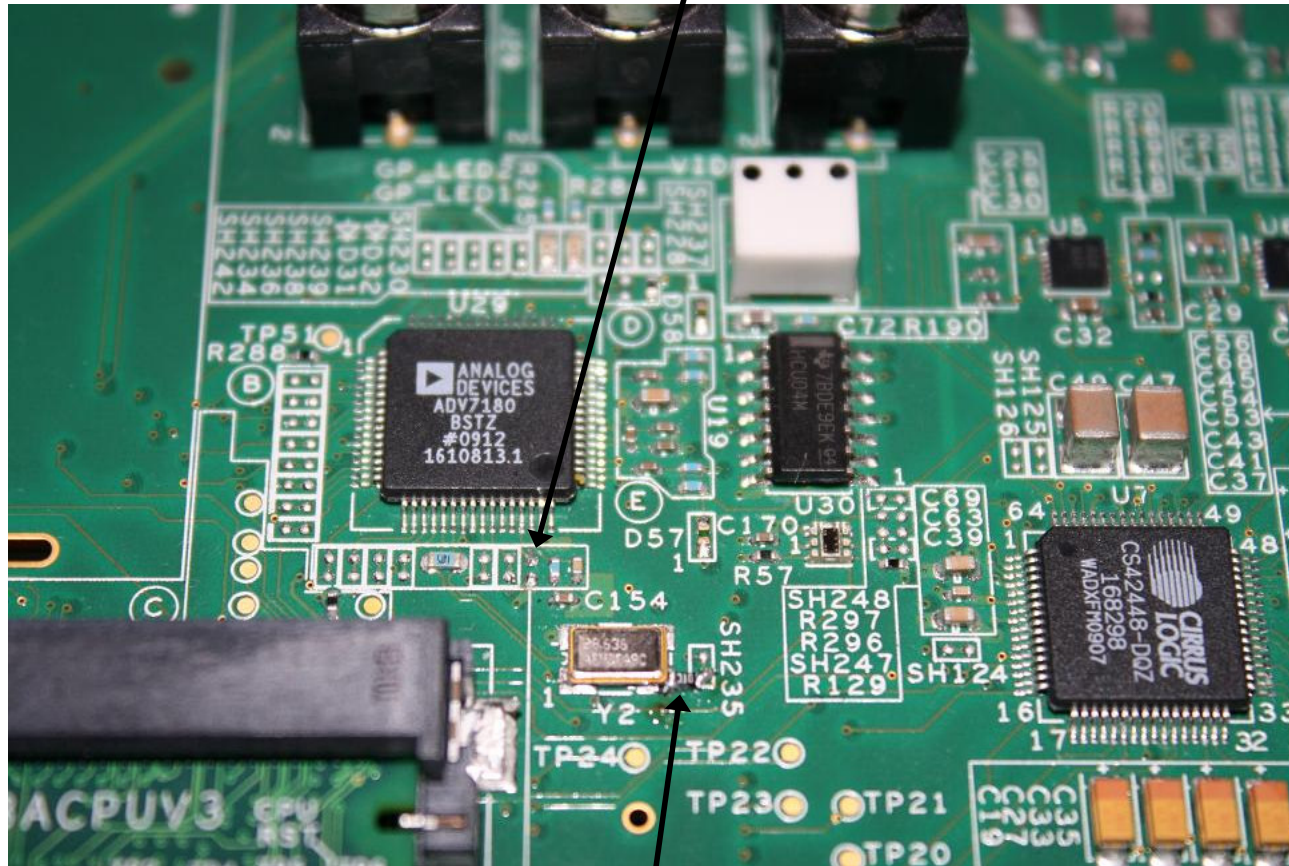
Remove R279

Fit 4K7 between Y2 pin 4 and SH235
